HMAS TOBRUK

JOINT COMMITTEE OF PUBLIC ACCOUNTS

REPORT 223

HMAS TOBRUK

DIAGRAM 4: HMAS Tobruk's Sewerage System: Original Design of Holding and Collection Tank

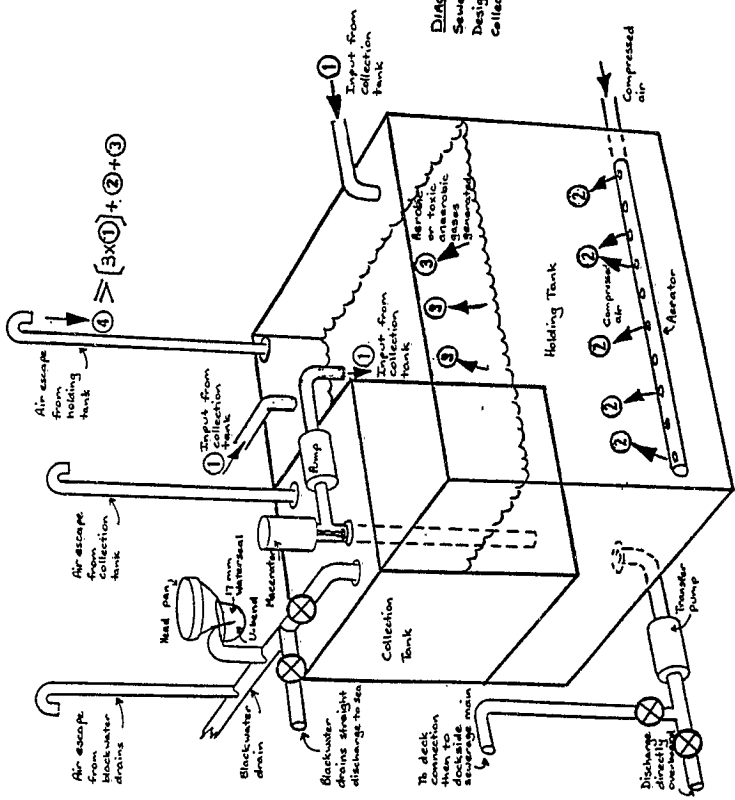
5.22 During the project changes were made to the Departments initial guidance drawing for HMAS Tobruk's sewerage system, to improve and simplify it. It appears however that at the time such changes were made not all of the details describing components to be incorporated were understood by the Department.

In retrospect, Navy's approval of the first change and development of the second change may have been ill-advised and, as indicated in the Review of the Board of Inquiry, they were contributing factors (among a number of others) in the Dax incident.

DIAGRAM 5: HMAS Tobruk's Sewerage System: Operation of Holding and Collection Tank after First Design Modification

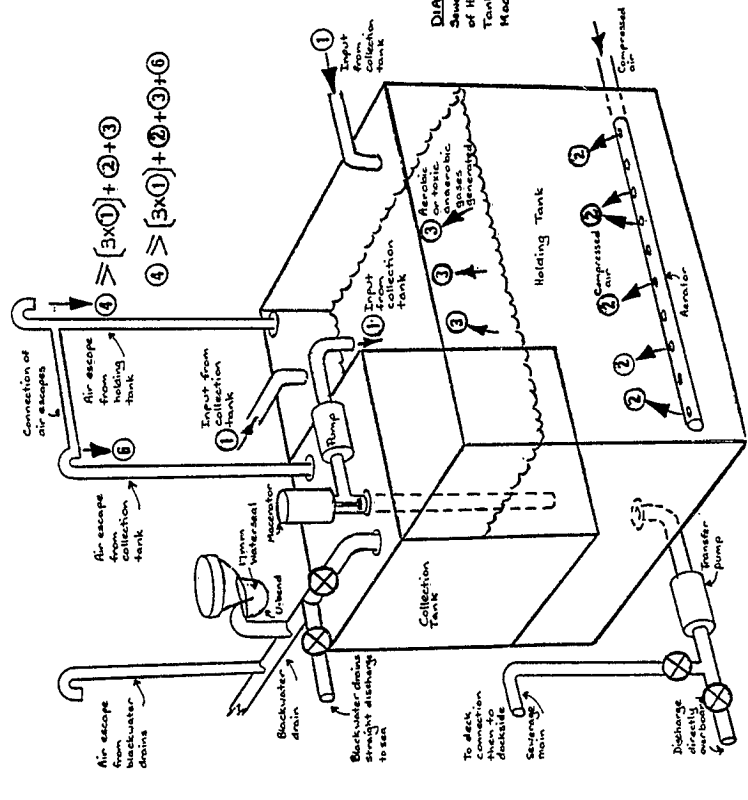
tanks at any one time. There is a requirement that the contents of the holding tanks should be constantly aerated with compressed air being supplied from a special compressor in the engine room. If copious quantities of air are not supplied constantly the chemistry of the microbiological decomposition which occurs in the holding tanks will be changed from aerobic to anaerobic. Gases are generated in both circumstances but they are different gases and are almost certain to be toxic when decomposition occurs in the absence of free oxygen. As I indicated earlier, the ship did not fully understand the plant and only operated the aerator compressor intermittently. The holding tank also has an air escape, which as originally designed, had to cope with the volume of air displaced by the discharge of up to three macerator pumps, plus the aerating air itself, plus the volume of product gases being generated within the decomposing sewerage.

Our calculations showed that the holding tank vent pipe did have sufficient capacity to cope with three times the inflow of the macerator pumps plus the aerating air plus the generated gases without raising the pressure in that tank significantly, or at all (ie. $4(3 \times 1) + 2 + 3$ on Diagrams 4, 5 and 6). The first modification that occurred was to connect the vent pipe from the port macerator tank to the port holding tank vent pipe so that the port holding tank vent pipe had the additional duty (no.6 on Diagram 5) which had previously been the duty of the macerator tank vent. Our calculations showed that this combined vent pipe is still big enough to cope with the addition of that displaced vapour or gas or air without creating an overpressure in the tank (ie. $4(3 \times 1) + 2 + 3 + 6$ on Diagrams 5 and 6). That first modification, of course, occurred during building. The next modification dates from August 1981. In this case, that same vent pipe had been connected to it a similar combined vent from the other side of the ship (see 7 on Diagram 6). The two then ran together up the starboard kingpost. So in effect, the new piece of pipe had to cope with twice the load that the individual tanks had to cope with earlier and our calculations have shown that it could not do so without a back pressure building up inside the vapour space of the holding tank (ie. $4(3 \times 1) + 2 + 3 + 6 + 7$ on Diagram 6). That pressure then had a path of course up to the atmosphere but if it were sufficient - and it was - it was able to track

GAS PATH MODEL.

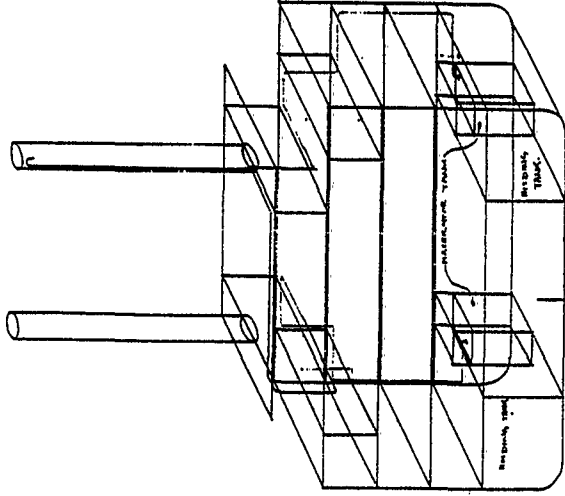
- a. It is found that, making the assumptions previously outlined, the pressure in the holding tank vent pipe at the collector macerator tank vent junction is increased from approximately 17Pa (0.1" WG) to 365Pa (1.47" WG) by modifying the vent system in accordance with Dept of Defence Drawing A200206. It is deduced that the pressure in the collector macerator tank is equivalent to the above pressure assuming that there is no flow through the collector macerator tank and that tank is a blind branch of the holding tank vent.

- a. This calculation shows that a large proportion of gas from the holding tank will flow back through the macerator tank to the heads during aeration if the water seals in the WCs are severely depleted or non-existent following the modification to the vent system in accordance with Dept of Defence Drawing A200206.
- b. Although the arithmetic in these calculations has been checked, the method is my own opinion and is unchecked by an independent person.
